Revised proposed head house at 37 Beacon Street

Owners: Robert Coffin & Rebecca Dietrich

Background

Points raised by BHAC in April

Internal layout – demonstrating why the stairs can't move further from Beacon St – the rest of the structure can & has been, however

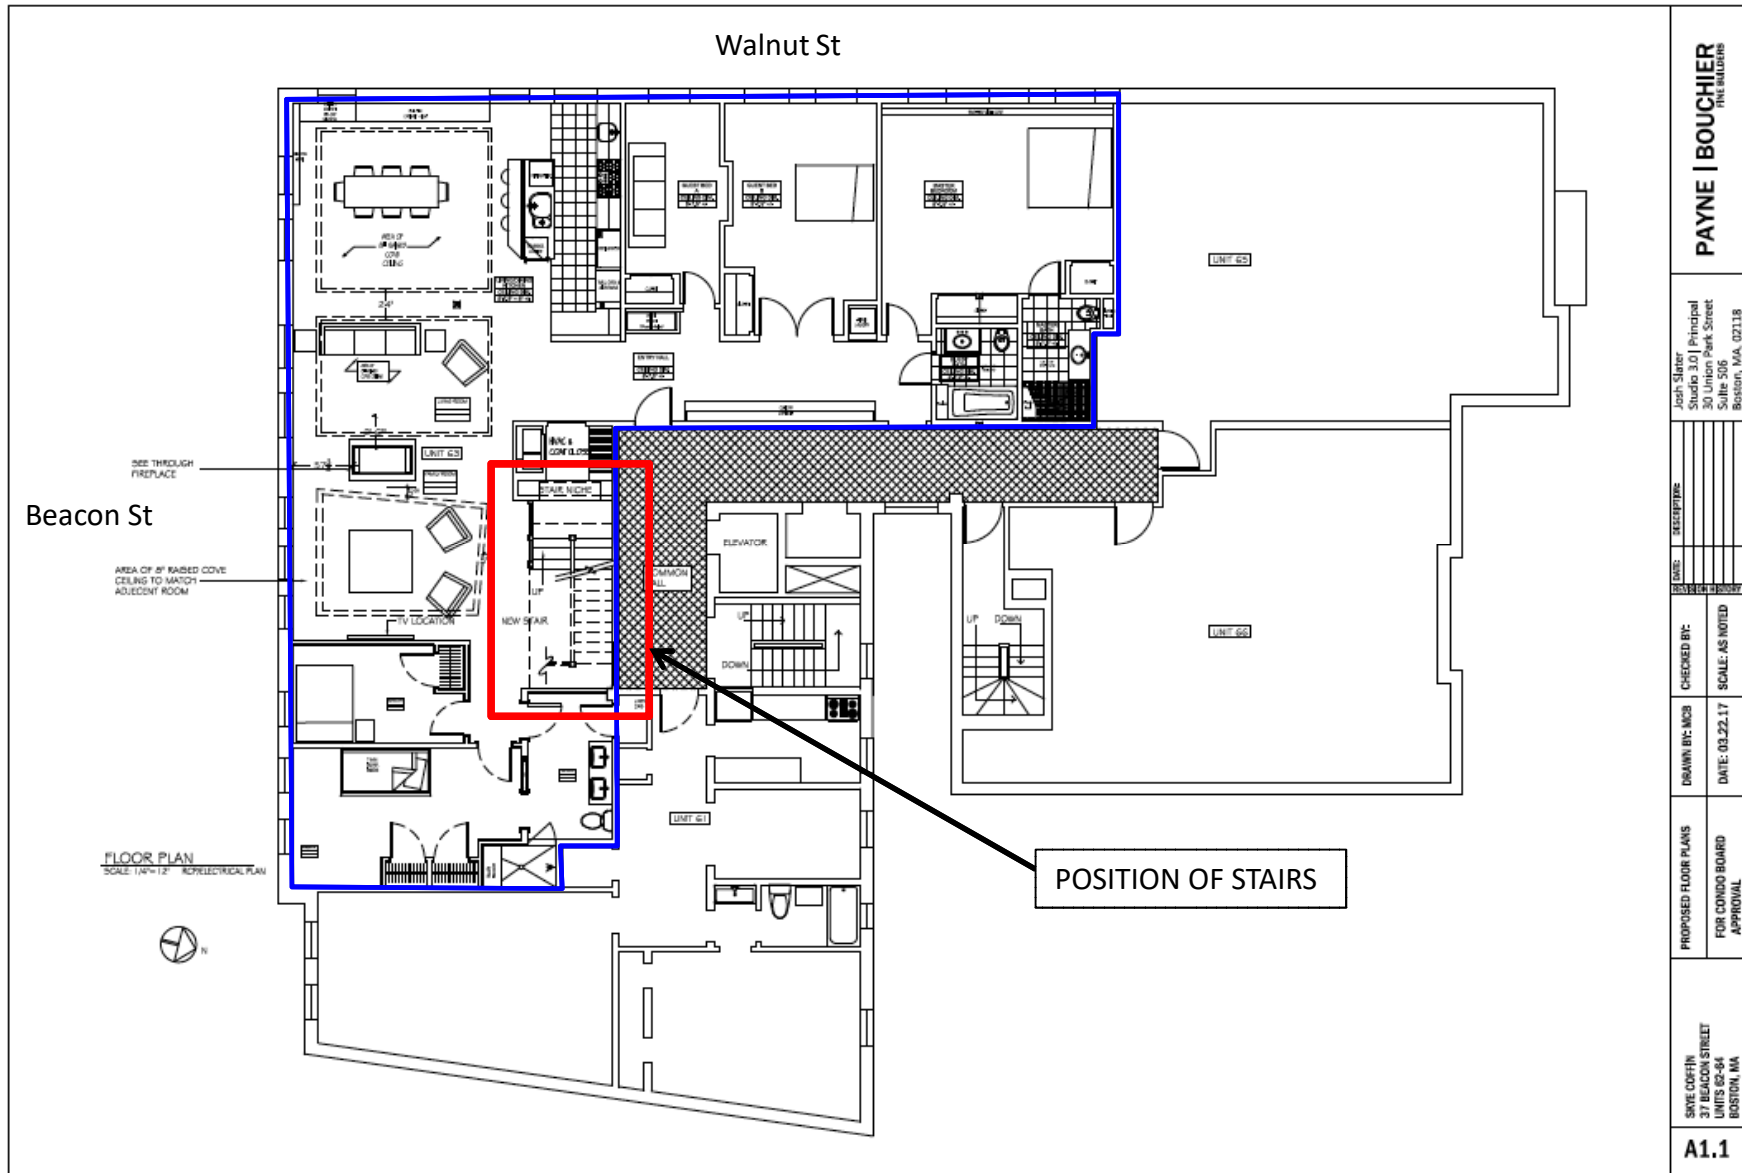
1. Position of the stairs

1. Due to the internal area of the apartment below, they are already as far from Beacon St as possible
 2. The current position in front of the current headhouse minimizes visibility, i.e. moving towards Joy St would increase visibility

3. The stairs cannot be moved towards Walnut St, as that is the area of the common roof deck to which the Applicants don't have roof rights
 4. The revised proposal has the stairs in the original position, as this is the only position they can viably be placed which also minimizes visibility

- However, the volume of the structure over the stairs has been cut by approximately 50% by following the line of the stairs for both flights (see revised plans).

- This moves the visible portion of the structure away from Beacon St by approx 3 ft, greatly reducing visibility
 - The floor area in front of the stairs has also been reduced to only that needed for a small landing, other parts of the revised structure (see "2. Solarium"), not being visible from public spaces.

- The resulting visible structure is therefore the minimum required to allow door access onto the deck, with a small landing (3ftx3ft)

Revised footprint, overlaying original

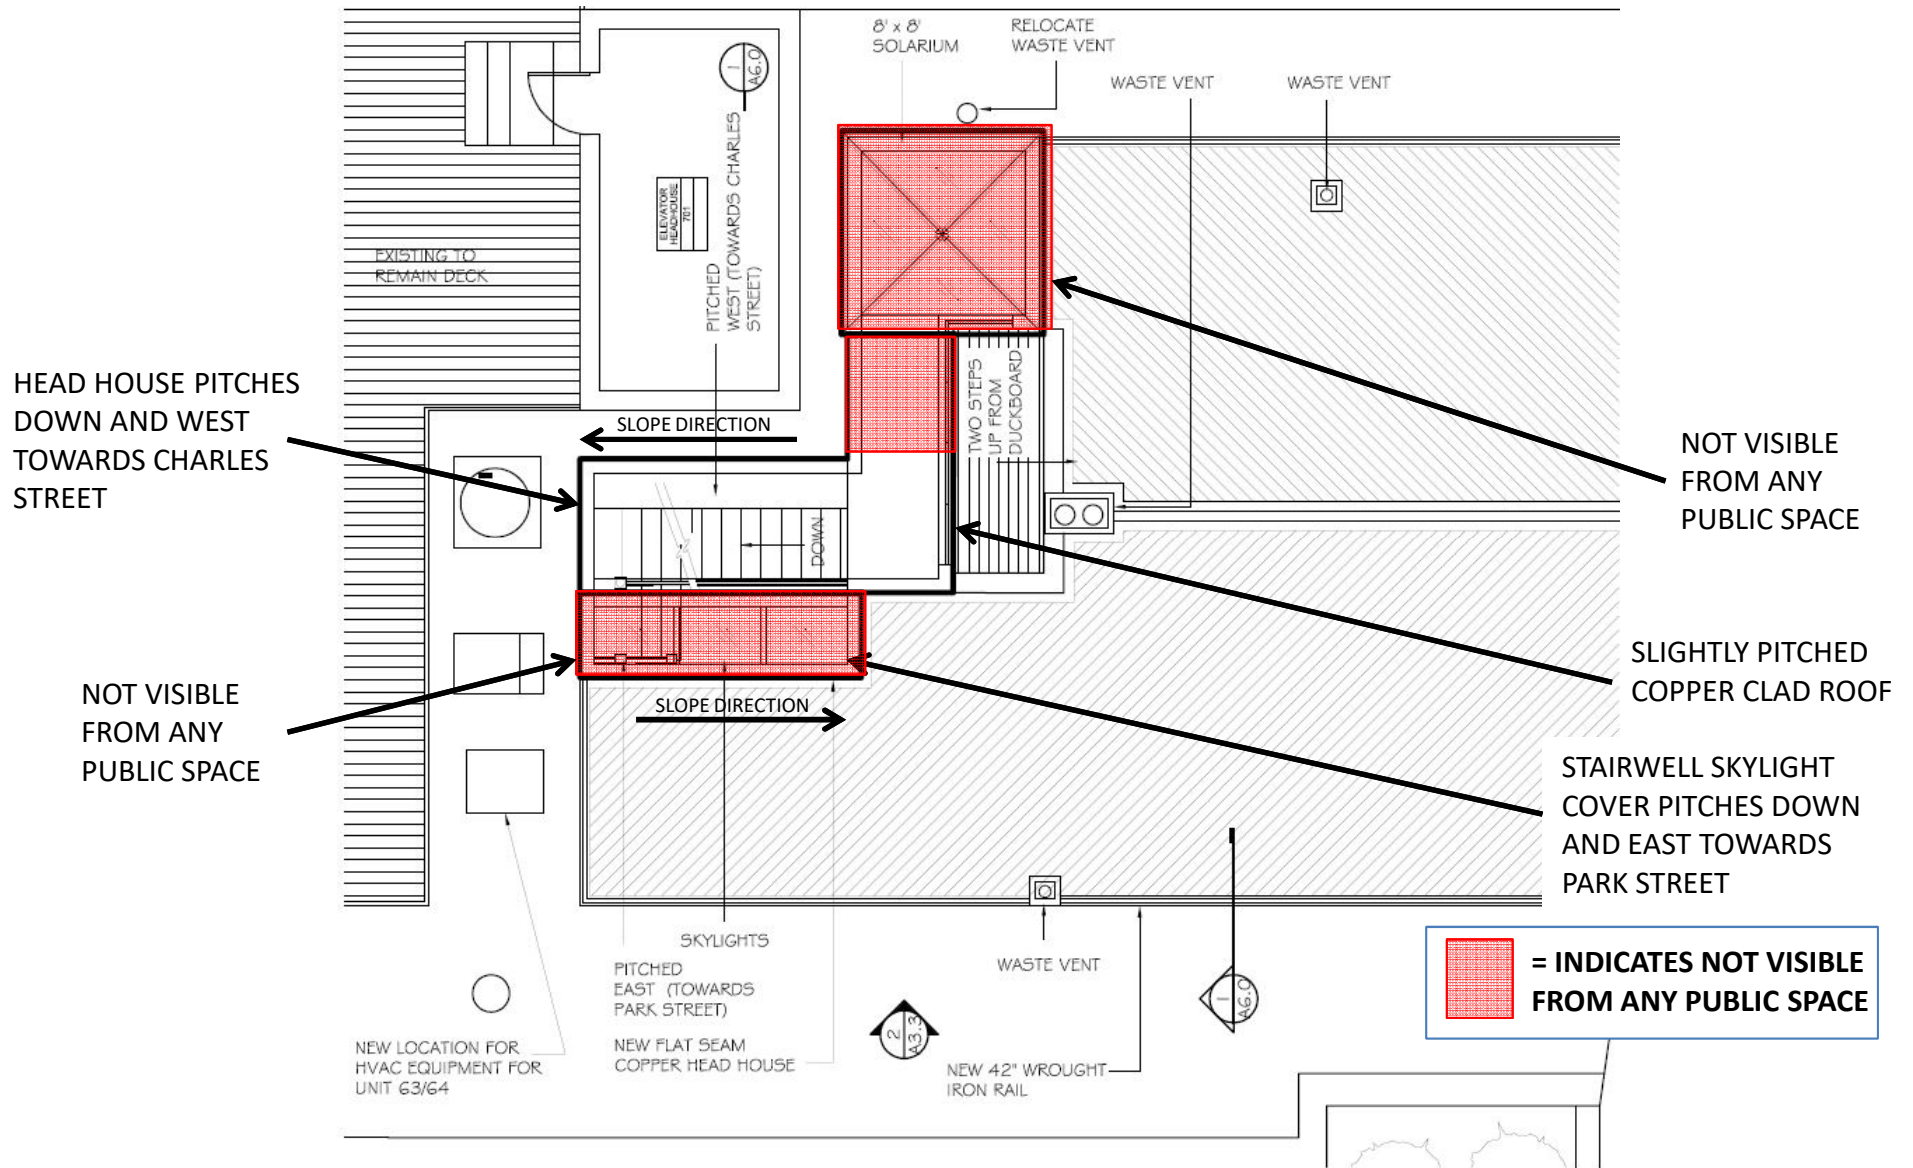
- BHAC indicated that the solarium was not necessary for roof access, and having the solarium increased visibility from public spaces
- The revised proposal reduces the size of the solarium, but more importantly positions it where it can't be seen from any public space, i.e. moves it as far back from Beacon St as possible
- Thus, other than the minimum structure required for door access (see previous slides), the remainder of the structure is not visible from any public space

**NORTH ELEVATION –
LOOKING AT BUILDING
FROM BEACON STREET**

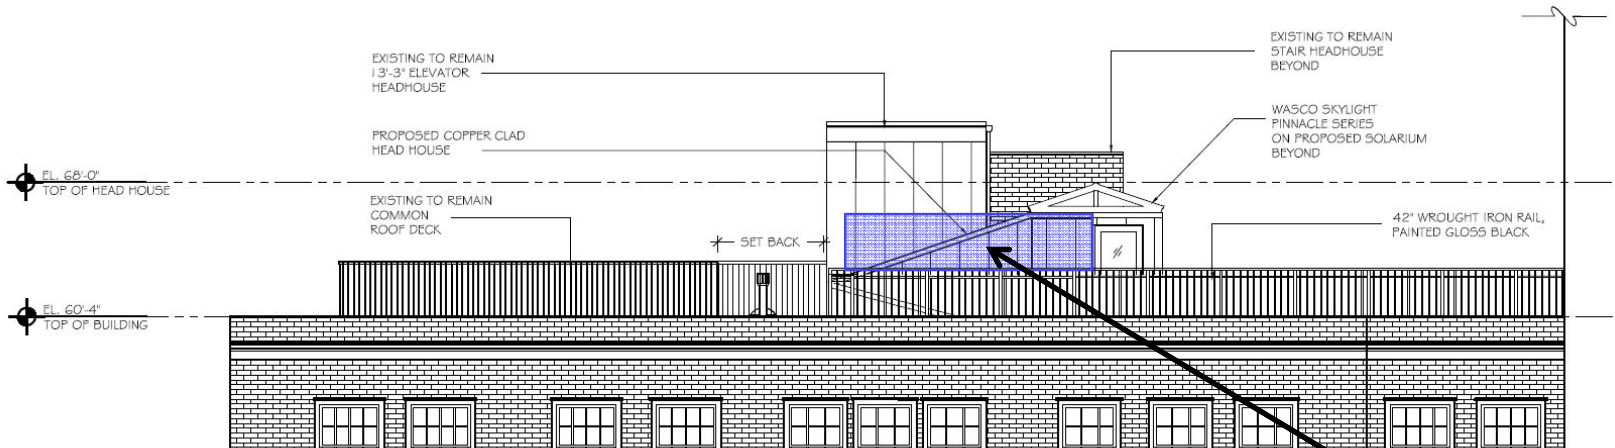
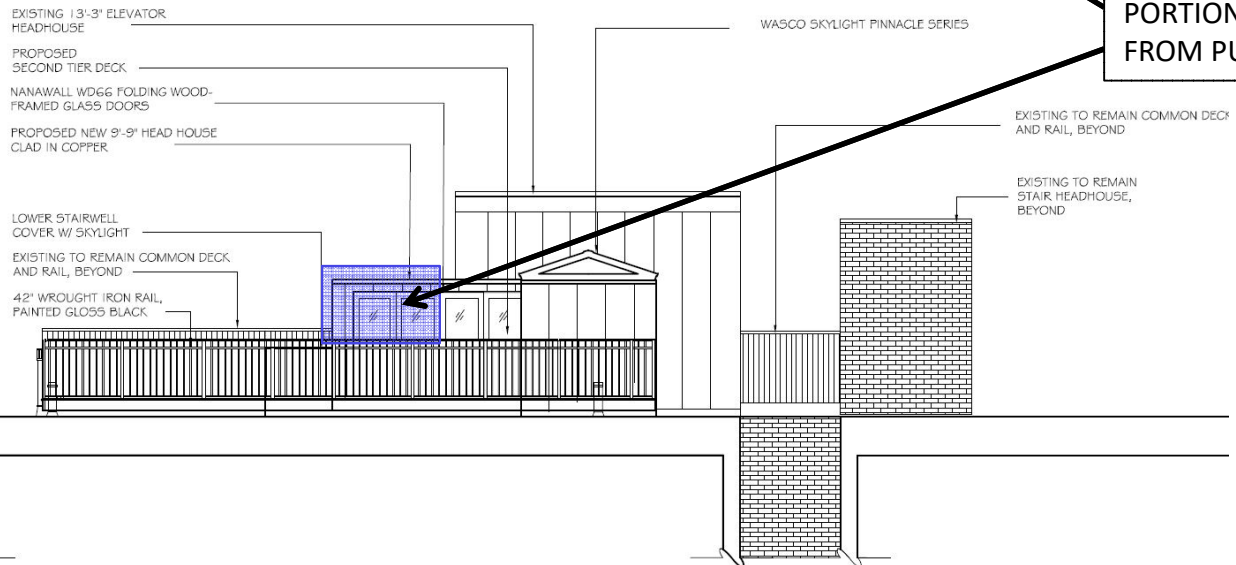
Reduced height stairwell cover – below railing height

**PORTION VISIBLE
FROM PUBLIC SPACE**

WEST ELEVATION –
LOOKING TOWARDS
CHARLES STREET

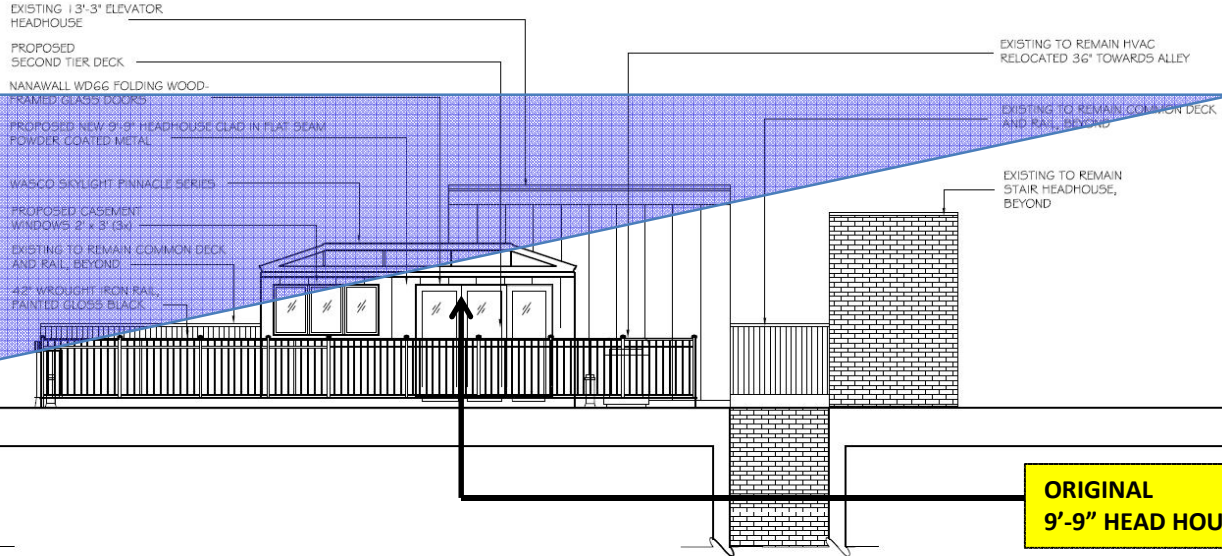
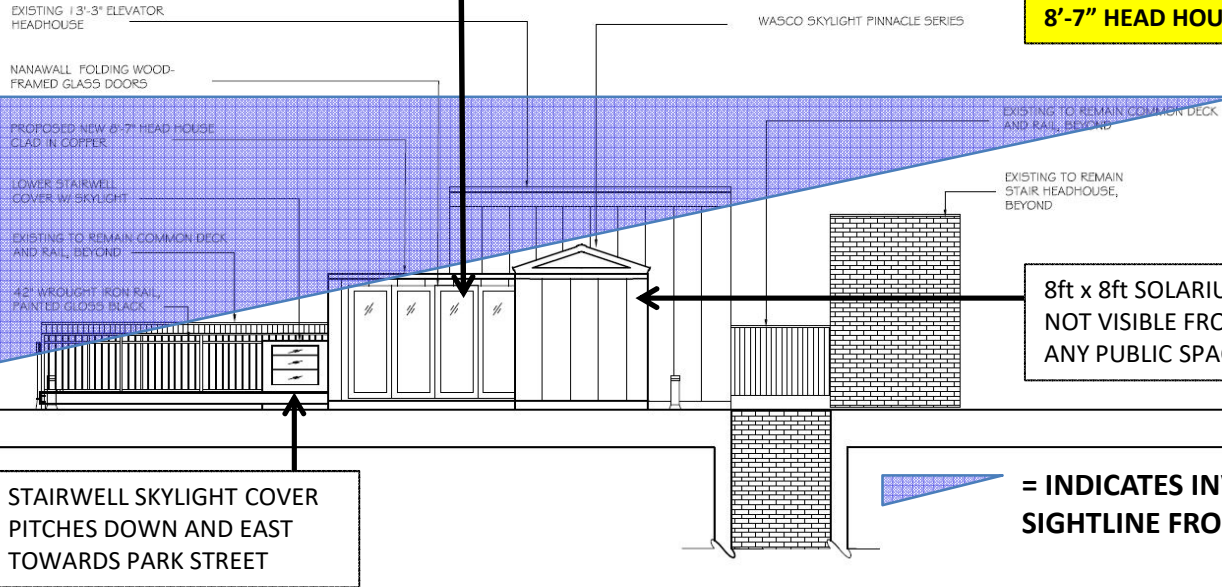
**ORIGINAL
9'-9" HEAD HOUSE**

**NEW PROPOSED
8'-7" HEAD HOUSE**

**8ft x 8ft SOLARIUM
NOT VISIBLE FROM
ANY PUBLIC SPACE**
